10 September 2019

**PLANNING PROPOSAL – DRAFT DEVELOPMENT CONTROL PLAN 2012 AND DRAFT VOLUNTARY PLANNING AGREEMENT AT 55 COONARA AVENUE, WEST PENNANT HILLS**

**RE: 55 Coonara Avenue, West Pennant Hills — Response to RMS Submission**

**Figure 1: Pedestrian Routes to Metro and Coonara Shopping Village**

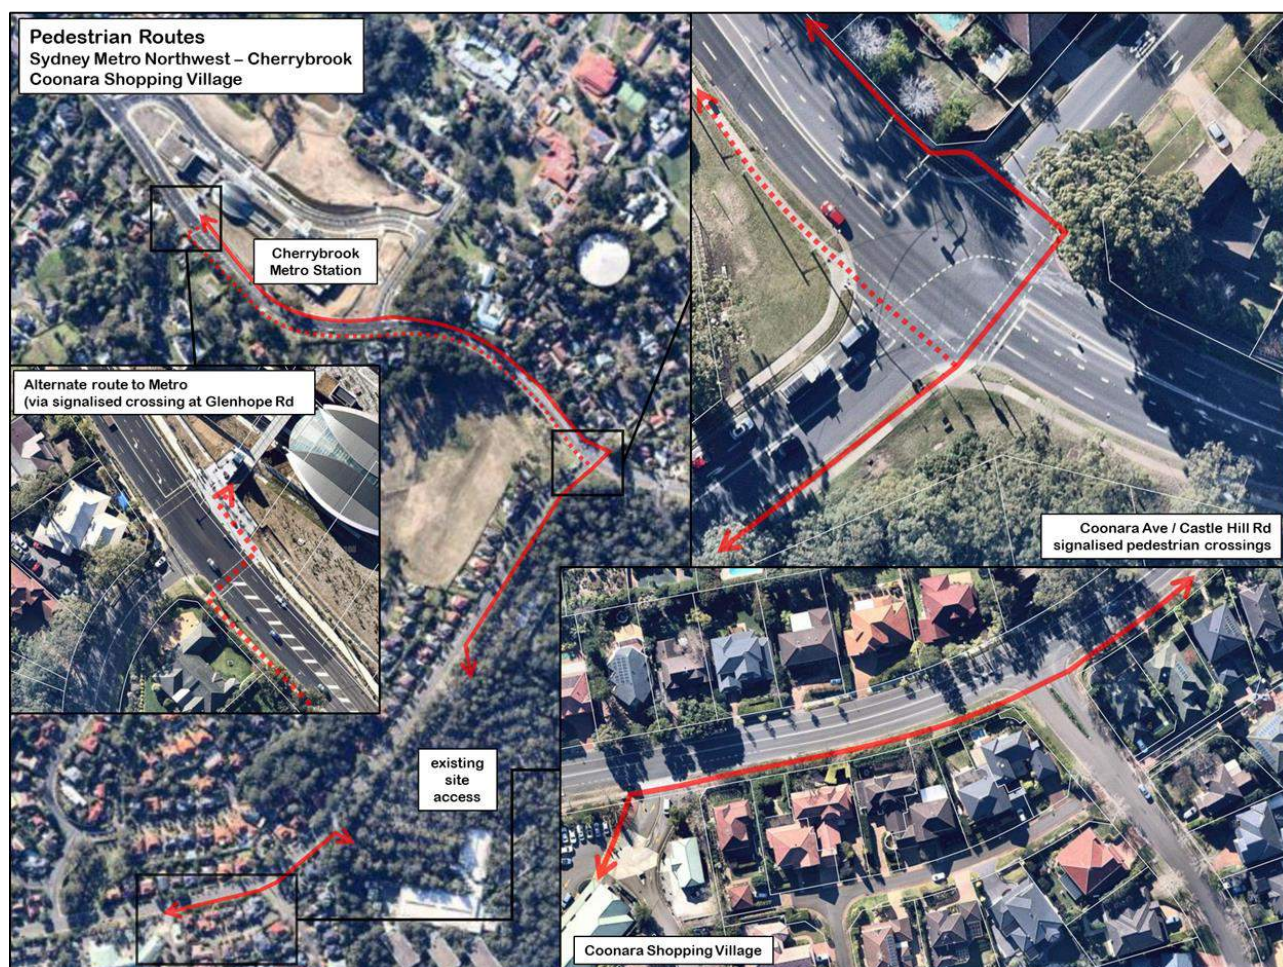
RMS Comment
<b>Connectivity with bus stops and active transport linkage</b>
It is noted that the Cherrybrook Precinct Structure Plan indicated that pedestrian/cycle access across Castle Hill Road is a key connectivity issue within the Cherrybrook area. To encourage connecting people to public transport as indicated in the planning proposal's supporting material Attachment H Traffic Assessment Report, consideration should be given to improving whole journey accessibility. The emphasis being on pedestrian and cycling amenity in line with the movement and place framework. This may include (but is not be limited to) provisions for safe and accessible footpaths, pedestrian crossing points (taking into account pedestrian desire lines) and cycle paths. These considerations will better meet the needs of the community in a way that supports a safe, efficient and reliable journey for pedestrians and cyclist in addition to reducing the congestion on the road network.

Notwithstanding, as shown in Figure 1 below, a pedestrian footpath is already in place along the site frontage, providing connections to:

- Castle Hill Road and on to Cherrybrook Metro Station, via signalised crossing points, and
- Coonara Shopping Village

Additional crossing points are not required to aid these desire lines.
